Watts Bar Nuclear Plant, Unit 2
NRC Docket No. 50-391

Subject: Watts Bar Nuclear Plant (WBN) Unit 2 – Final Safety Analysis Report (FSAR) – Response to Requests for Additional Information

Response to RAIs Regarding Unit 2 FSAR

AFW RAIs (NRC verbal request of 01/12/2011)

Condensate Storage Tank (CST)

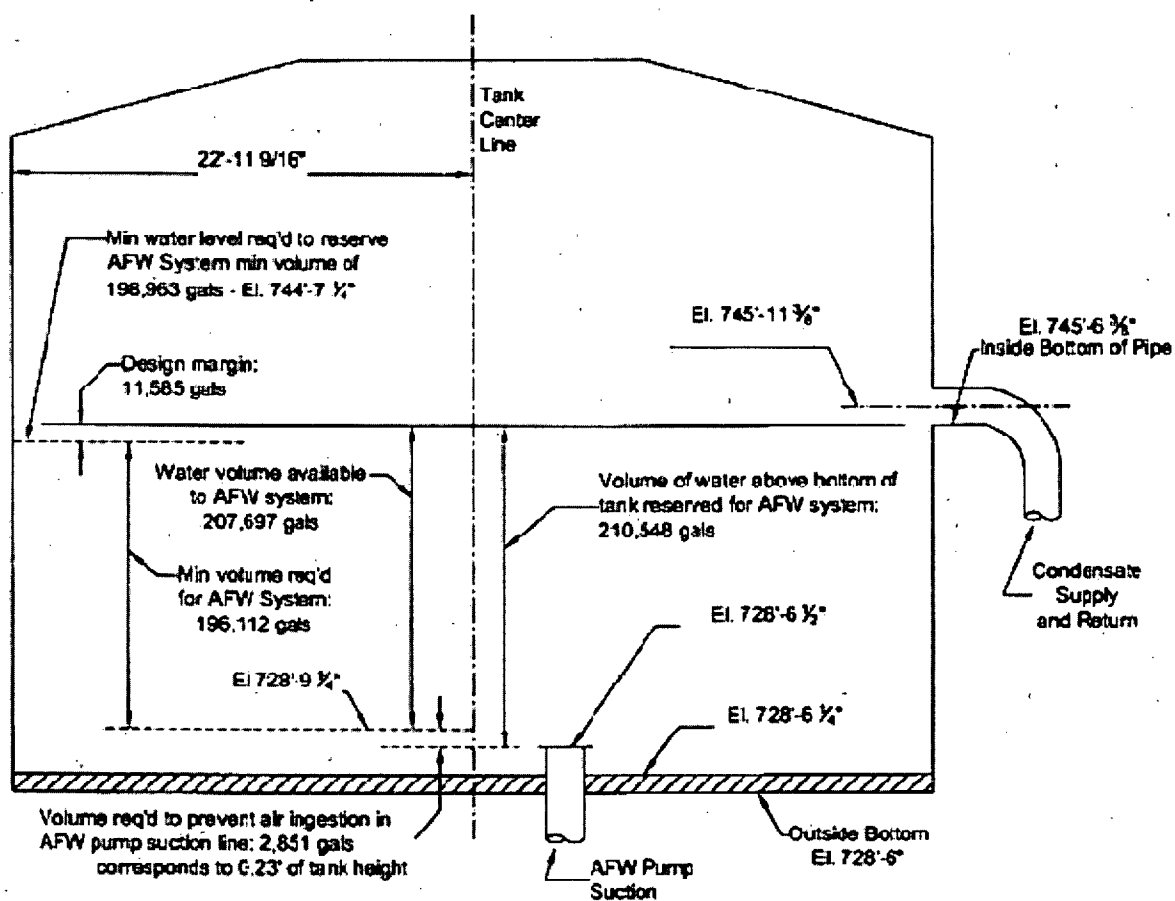
AFW - 1 What is the basis for the value in the Tech Specs for CST level?

Response: Unit 2 Technical Specifications Limiting Condition for Operation (TS LCO) 3.7.6 states, "The CST level shall be $\geq 200,000$ gal."

As described in the TS Bases for LCO 3.7.6, the CST level required is equivalent to a usable volume of $\geq 200,000$ gallons, which is based on holding the unit in MODE 3 for 2 hours, followed by a cooldown to RHR entry conditions at $50^{\circ}\text{F}/\text{hour}$. This basis is established in the CST level calculation and exceeds the volume required by the accident analysis.

The quantity of feedwater required to bring the plant down to RHR cut-in conditions is 196,112 gallons, including a 3,000 gallon allowance to account for AFW Pump Heat described in Westinghouse Technical Bulletin TB-09-4, "Impact of Auxiliary Pump Heat on Westinghouse and Combustion Engineering Analyses / Methodologies."

There is 2,851 gallons of water unavailable due to vortexing / air injection, which results in a minimum required volume of CST water of 198,963 gallons. This is less than the TS requirement of $\geq 200,000$ gallons.

See Figure on next page.
